33220A-02

S E R V I C E N O T E

33220A 20 MHz Function/Arbitrary Waveform Generator

Encoder S1 (P/N 0960-2545) May Be Subject to Early Failure

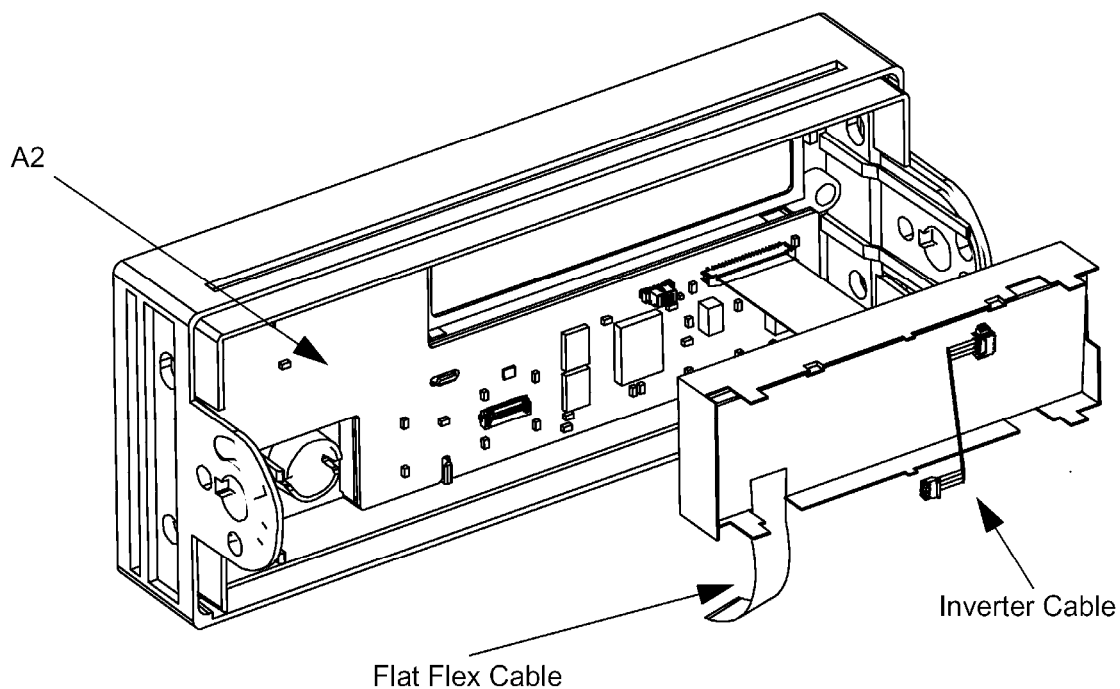
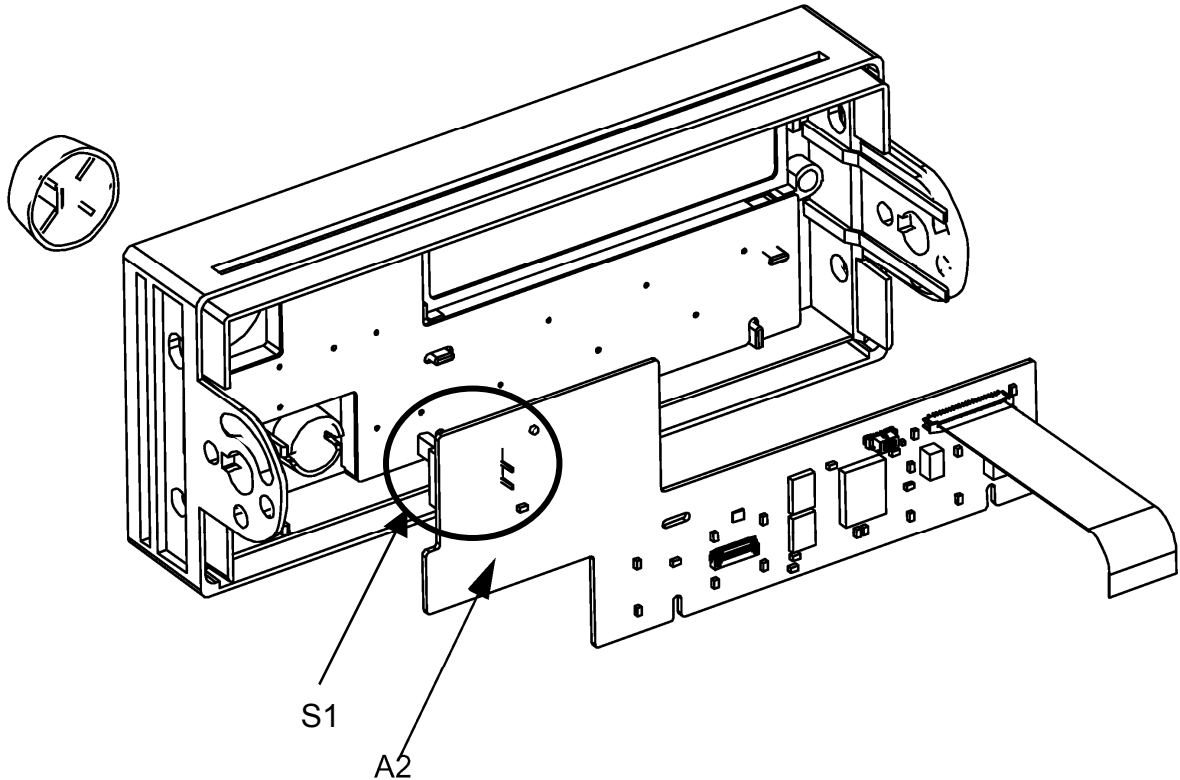
4. Replace one of the following assemblies:
 - A2 front panel board, part number 33220-66502
 - S1 encoder, part number 0960-2545. Proper soldering techniques are required when removing/replacing so as not to permanently damage the printed circuit board.
